DCRT
TEN WEST LINK TRANSMISSION LINE PROJECT
**MINOR PROJECT REFINEMENT
REQUEST FORM**

Date Submitted:	5/23/22	Request #:	001
Date Approval Required:	5/31/22	Landowner:	BLM, Private
APN:	Multiple		
Refinement from (check all that apply):			
<input type="checkbox"/> Mitigation Measure	<input checked="" type="checkbox"/> APM	<input checked="" type="checkbox"/> Project Description	<input checked="" type="checkbox"/> Drawing
<input checked="" type="checkbox"/> Other (please specify): See attached summary (<i>Attachment A</i>) for all changes and their purpose			
Identify source (mitigation measure, project description, etc.):			
<i>Please refer to Attachment A Tables 1, 2 and 3 for summaries of all refinements to the POD since February 2021 that are being requested, as well as a description of the purpose of each change.</i>			
Attachments (check all that apply):			
<input checked="" type="checkbox"/> Refinement Screening Form (Attachment B)	<input type="checkbox"/> Photos	<input checked="" type="checkbox"/> Maps (Attachment C)	<input checked="" type="checkbox"/> BLM Variance Request (Attachment E)

ATTACHMENT A: SUMMARY OF REQUESTED CHANGES AND THEIR PURPOSE

Table 1 - Mapping/Impact

Page 3 of 37

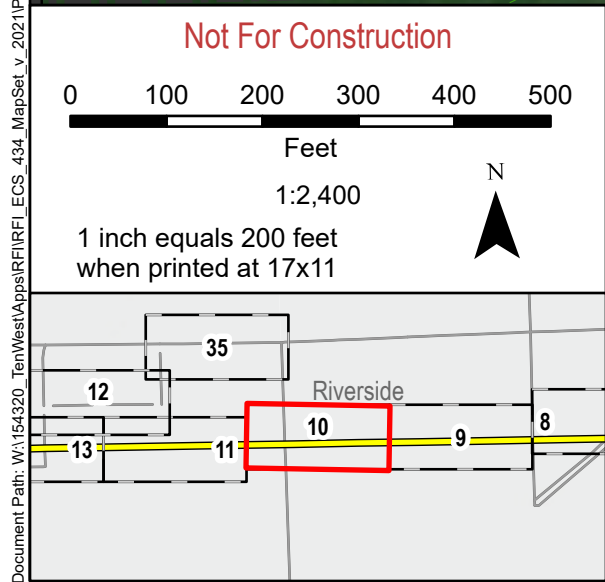
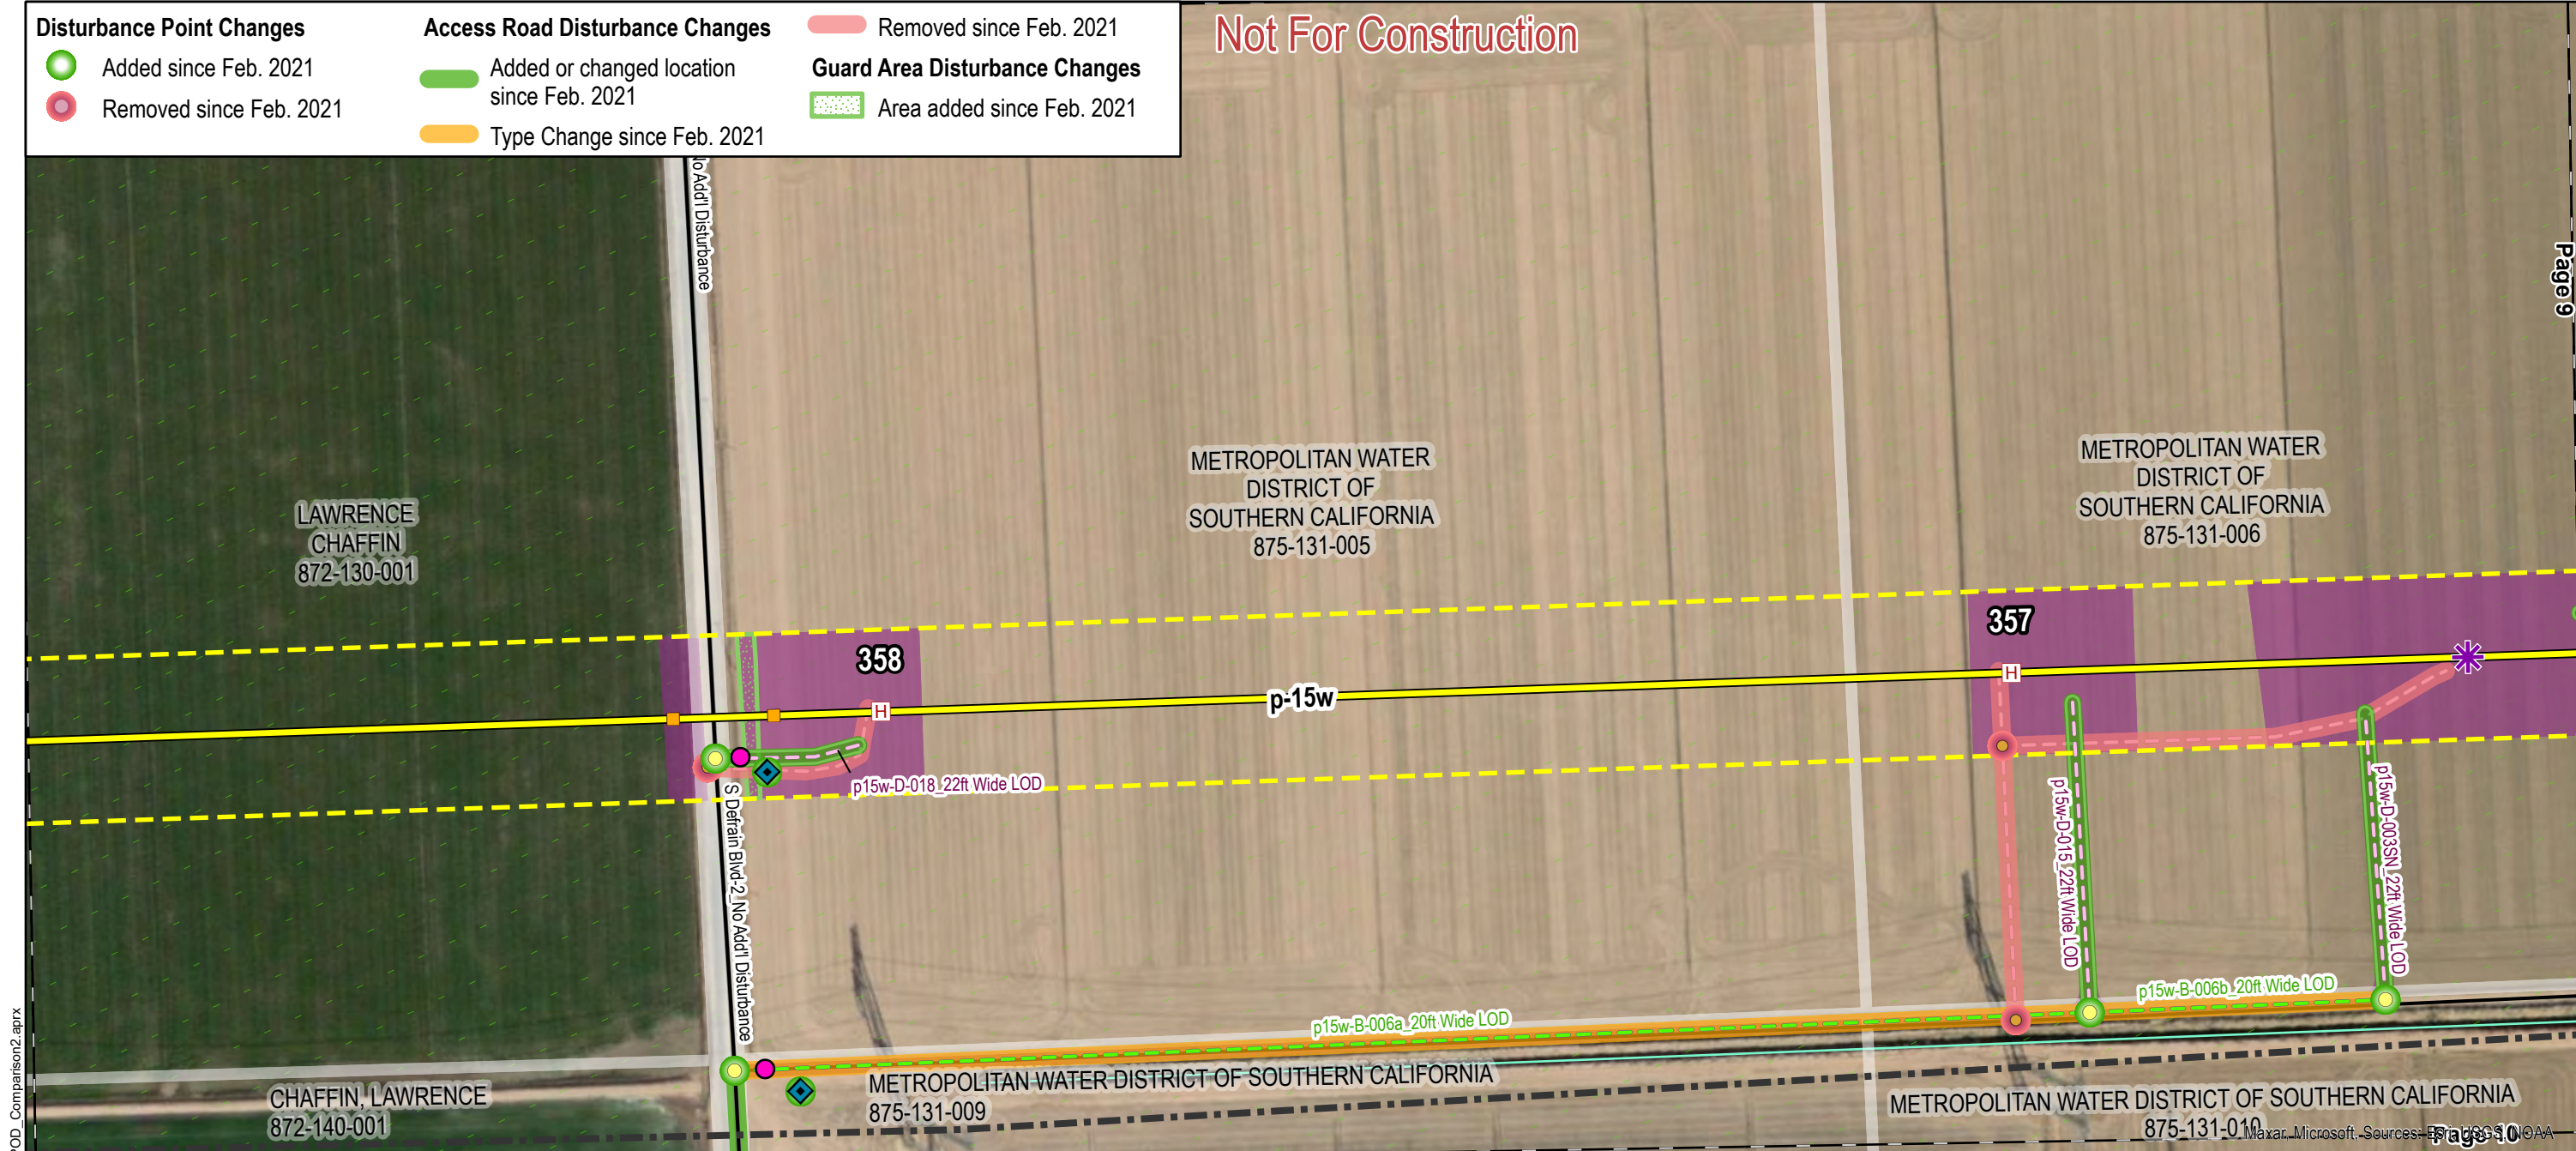
MPRR 001-23	Mapping, MPRR Map Pages 3, 4, 7-10, 15, 17, 22, 24, 25, 35	Wheel wash locations added; includes 10x50-foot wheel wash pad to park the equipment next to the driveway.	MM AQ-CEQA-1 requires "A wheel washing system shall be installed and used to remove bulk material from tires and vehicle undercarriages before vehicles exit the unpaved construction site." As such, the wheel washes are shown on the maps. A wheel was support pad was added to reflect that an area would be needed on the private lands next to the driveways to park the washing equipment.
MPRR 001-24	Mapping, MPRR Map Pages 7, 36	Two water withdrawal rock pads added to the disturbance mapping where water trucks would park to withdraw water from the agricultural canals; this type of disturbance area was not originally considered in the POD.	Previously, the water withdrawal areas were positioned along existing access roads. PVID indicated that they would not be able to allow water withdrawal from the canals feeding the agricultural lands, and proposed two alternative locations where water could be withdrawn from the drains. These withdrawal areas would require a rock pad to be installed so that ground was stabilized and the sites did not become muddy where the water trucks would fill up. (Approximately 3,300 to 5,400 square ft) Coordination with PVID is ongoing; the current plan which differs from the POD mirrors the original plan to withdraw water from the irrigation canals that feed the agricultural lands. Consultation with PVID is ongoing, and a new MPRR will be submitted to reflect the final plan. Any approved permits or agreements with PVID will be provided in the SharePoint drive when available.

MPRR 001-27	Mapping MPRR Map Pages 3, 5-11, 13-16, 18, 19, 23, 24, 26, 29	<p>Added 1.2 acres of temporary Type D access roads in the California agricultural lands</p> <p>Added 1.5 acres of temporary pull out areas in the California agricultural lands, since the roads were changed from Type A to Type B.</p>	<p>This is the total change in acreage as a result of the mapping refinements in the California agricultural lands.</p> <p>Note – pull out areas are not shown in mapping. As described in POD Appendix K-1, Section 3: “The pull-outs will be sited no closer than 1,000 feet on a single access road.... The pull-outs will be placed at the operator’s discretion and may be spaced greater than 1,000 feet. These areas are considered temporary in nature where they are not necessary for operation and maintenance.”</p>
MPRR 001-28	Mapping, No map pages provided since this was only the assignment of acreage for Table 3 and not an on-the-ground mapping change.	Snub sites in ca-07 and p-16 reduced by 0.4 acres	The snub sites were trimmed due to landowner and/or cultural avoidance. The POD previously assumed 2.75 acres for all snub sites. The impact acreages in Table 3 were updated to reflect the acreage of the actual trimmed polygons provided in the POD mapping.

Guard Pole Changes

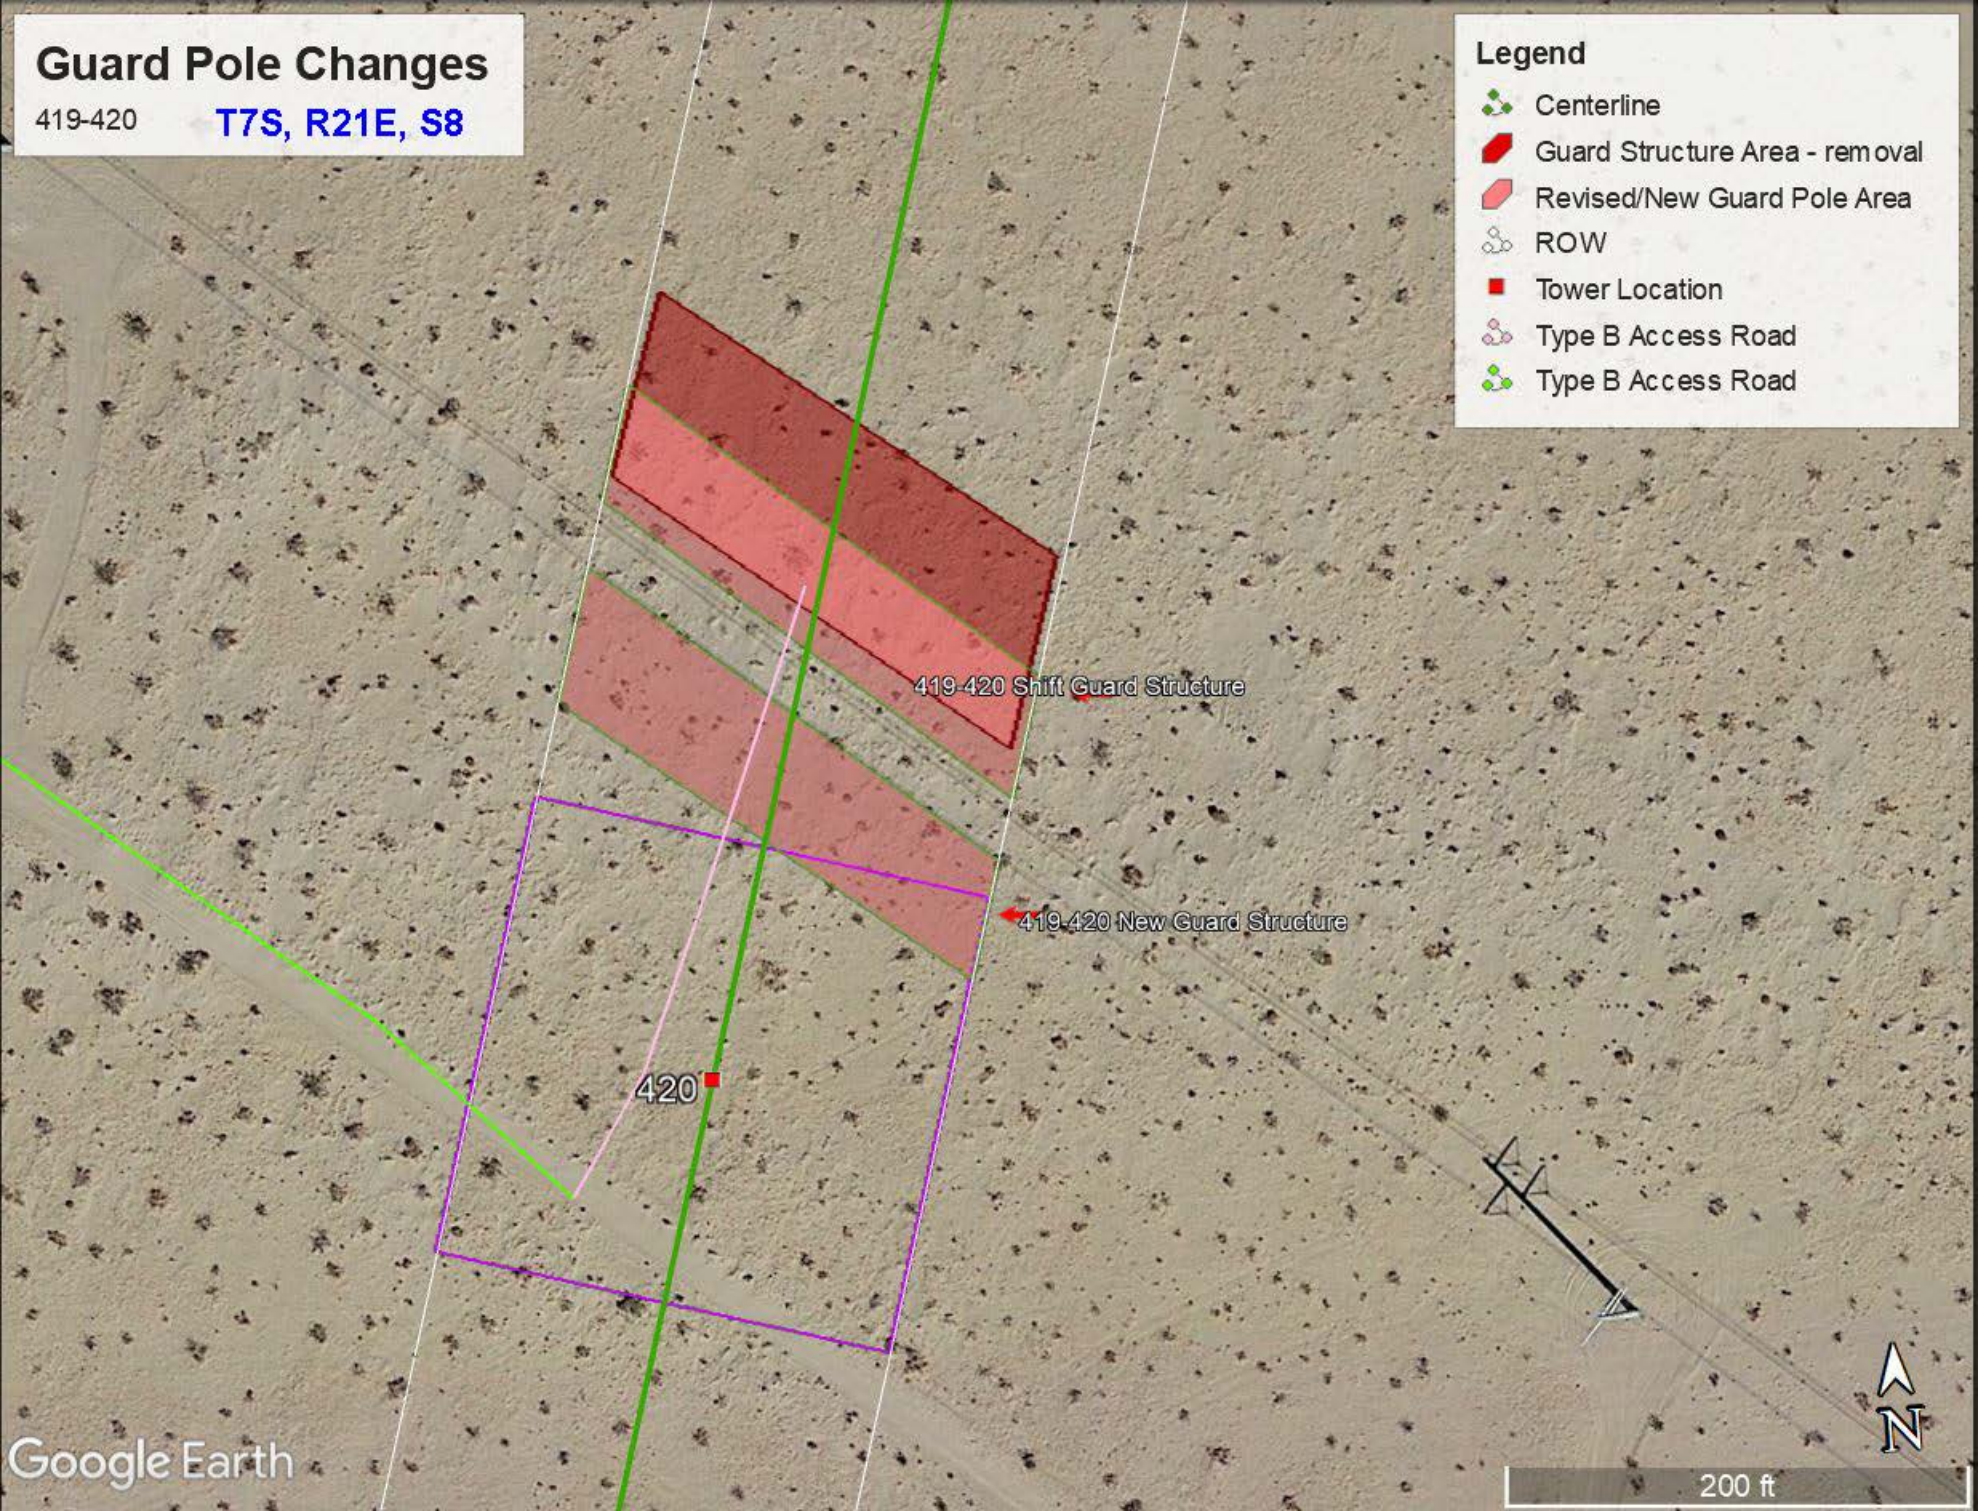
MPRR 001-29	Mapping, MPRR Map Pages 1, 2, 5, 6, 8-11, 13-16, 18-20, 23, 24, 26, 29, 32, 33	<p>Guard pole area changes in California</p> <ul style="list-style-type: none"> • Shifted 12 • Removed 39 • Added 4 <p>Ultimately reduced the temporary guard pole acreage by 7.2 acres. This 7.2 acres includes impact changes contained in BLM Variances 16 and 18, which are provided in Attachment E).</p>	The construction contractor’s wire superintendent reviewed the wire pulling plans and refined all the guard pole areas across the Project, which resulted in these stated changes to the California area.
